SUBJECT: Responds to NRC 790801 request for addl info re
 recirculation sump. Model test to be completed by Nov, 1979.
 Sump location drawings encl.

September 24, 1979
AEP:NRC:00260

Donald C. Cook Nuclear Plant Units No. 1 and 2
Docket Nos. 50-315 and 50-316
License Nos. DPR-58 and DPR-74
Request for Additional Information Regarding Recirculation Sump

FIGURE 1 LOCATION OF SUMP WITHIN CONTAINMENT BUILDING

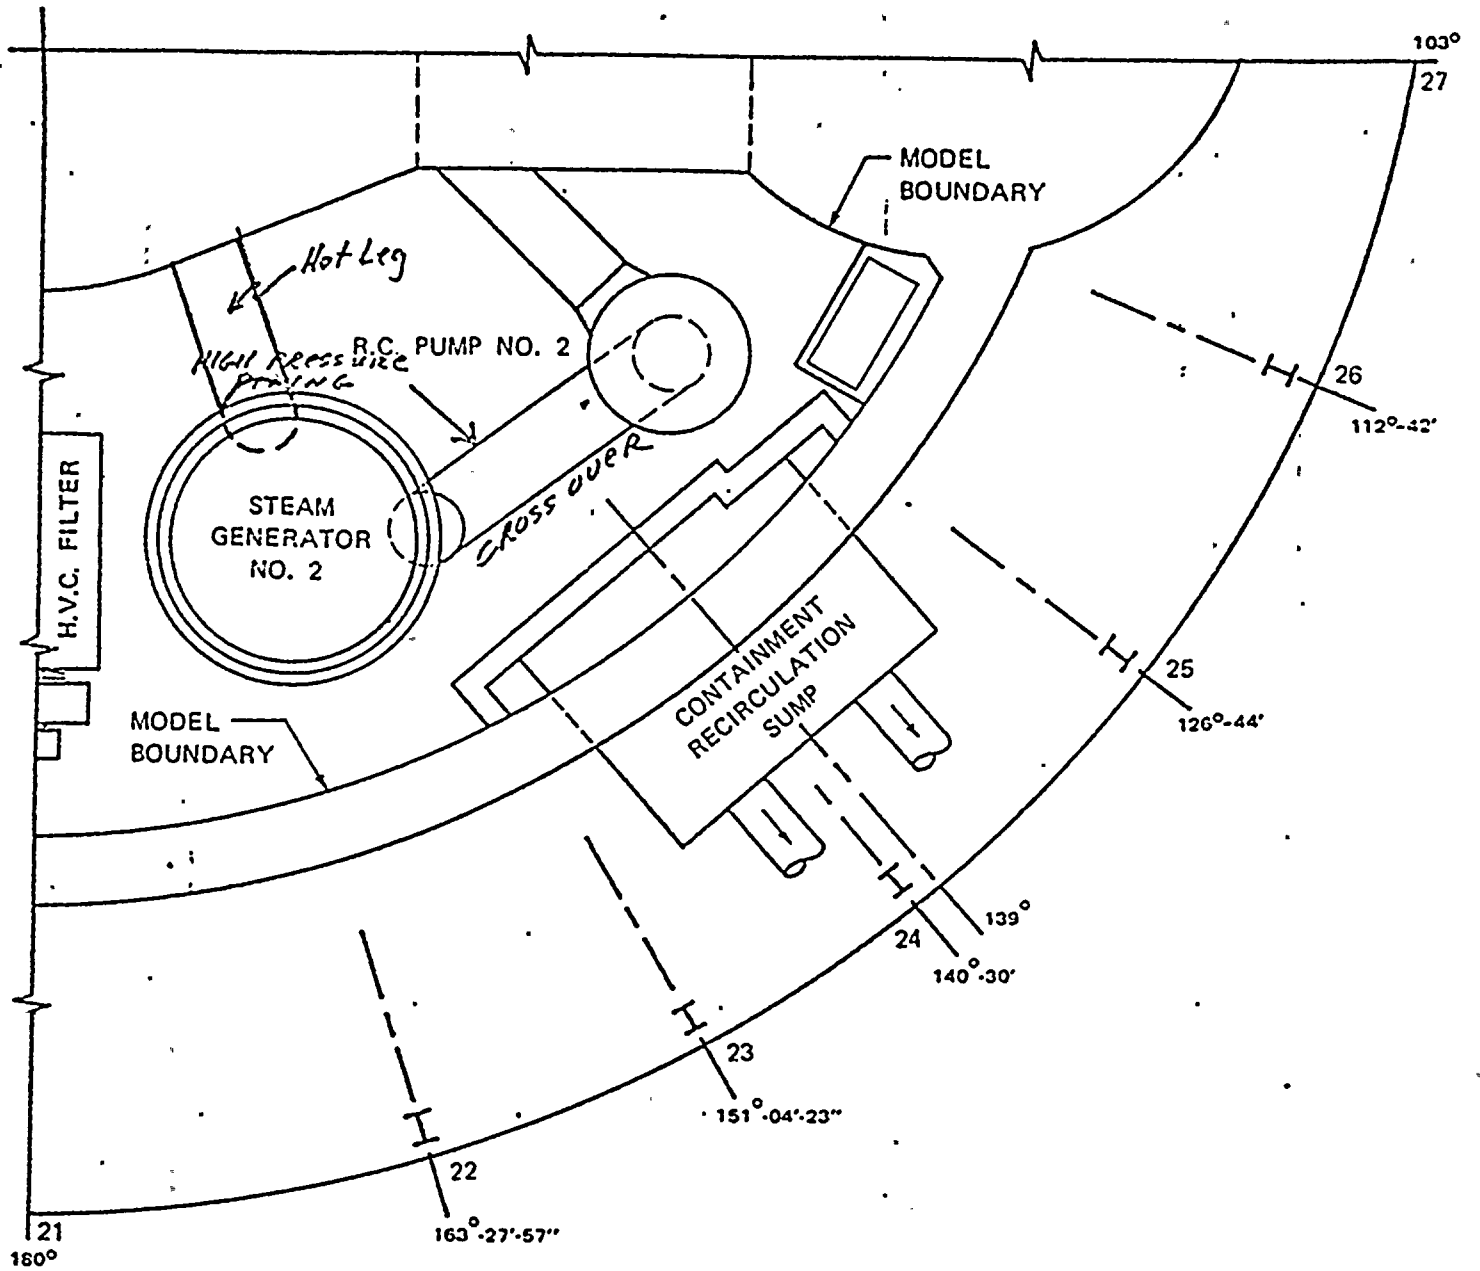
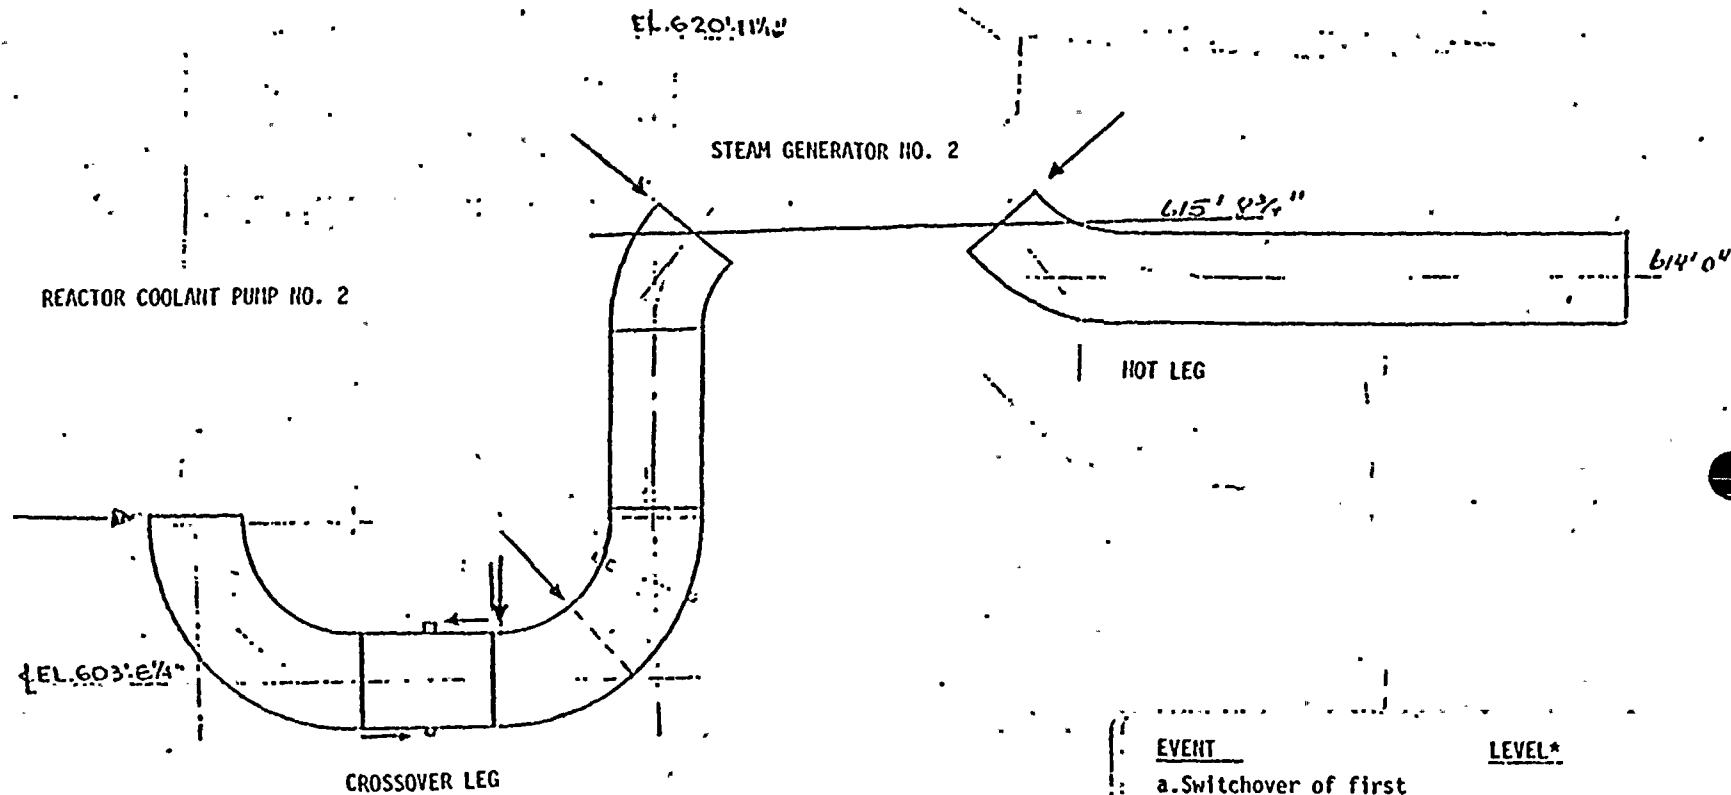
In response to Item 2 of the subject request, Figures 1 and 2 of Attachment 1 are enclosed. The figures are marked to indicate break locations being considered and containment water levels at various switchover points. The piping segments shown in Figure 2 which is an enlargement of Section B-9 of FSAR Figure 5.2-5 represent the only high pressure piping in the vicinity of the recirculation sump.
